# Rezoning Transportation Analysis

Petition Number: 2023-062

Date	Description
8-24-23	First Review (JT)
2-21-23	Second Review (NK)

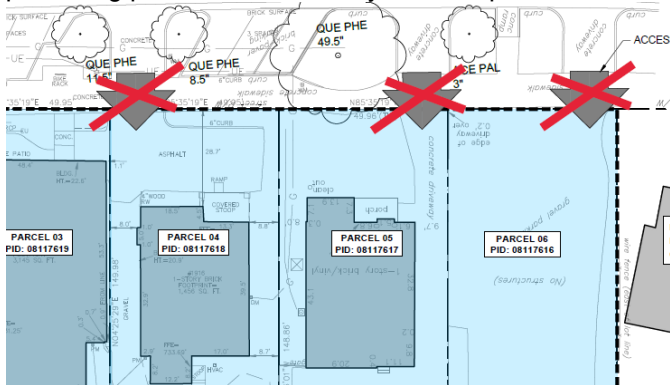
### 2. **Revise site plan to remove all access points as shown below. Driveways will be reviewed during the permitting process once density and site plan information are known.**
